Reply to Referee, Referee #3

We thank the Referee 3 for the thorough review of this manuscript and really appreciate the comments and suggestions. They have significantly contributed to improve the quality of the publication. Please find below a detailed response to the each of the general, specific and minor comments.

Figure 1: Case example of AOD correction after K-ciclo procedure (October 29th, 1987)

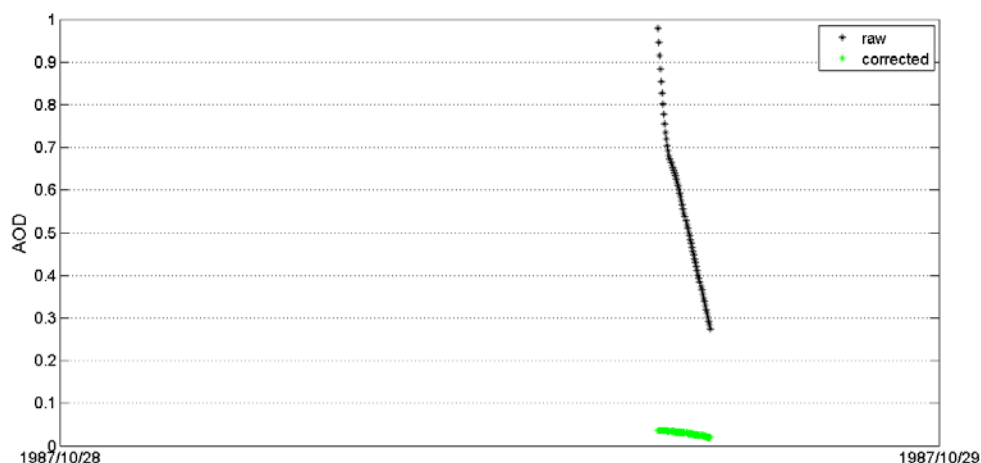
GC#1: Several aspects regarding the calibration are not convincing: the rapid changes in V0 suggest large uncertainty; the AOD diurnal cycle corrected by Cachorro et al method also suggests that the Langley procedure was not satisfactory in many cases/periods. Why only cases with AOD diurnal cycle >0.3 are subject to recalibration? This seems arbitrary and not consistent.

We performed a first recalibration procedure, accounting for those events in which amplitude in AOD was >0.3 (see figure 1 as a case example). These events are characterized by extremely high AOD values that need to be corrected first. The second stage involves AOD < 0.3 (see fig. 1 referee 2 comment) and the last one is devoted to correct negative AOD values (when the AOD is very low; AOD<0.03). The threshold set in 0.3 is not arbitrary since it was selected according to the exhaustive data analysis performed in the validation procedure.

Figure 2: 20 days evolution of AOD extracted from Mark-I, Cimel-AERONET and GAW-PFR.

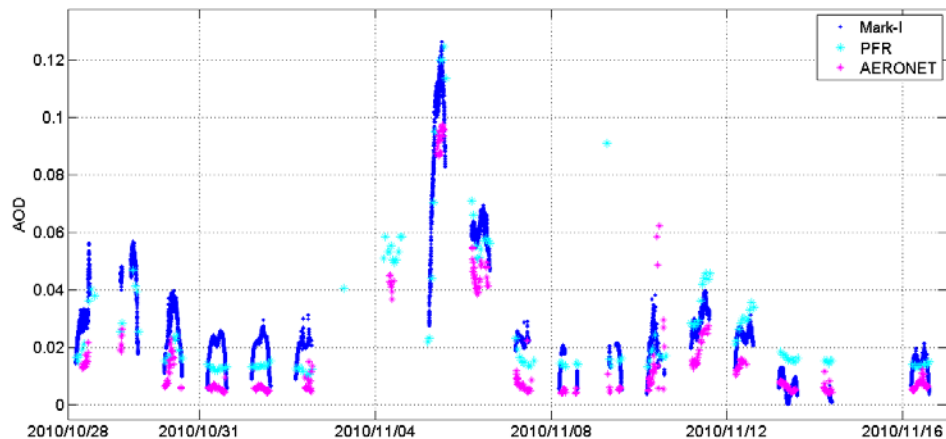
GC#4: The dataset must be shown: a short time series of about 1 week from both Mark1 and PFR would allow a visualization of the data quality. Scatter plots of Mark1 and PFR/Cimel data are needed.

>> Scatterplots have been included for every year of the intercomparison with PFR and Cimel (see referee 1 CG#1 and referee 1 figure 8). The short time series is presented in Fig. 2. We can see a good agreement between Mark-I and PFR/AERONET in cases of low and high aerosol content but it is clearly visible the fictitious diurnal cycle affecting Mark-I data. However, it seems that PFR and AERONET level 2 data are also affected during Oct 29th and 30th. It is clear that the fictitious amplitude in AOD as a result of calibration problems is a common problem in sun-photometry and it is not only restricted to Mark-I.
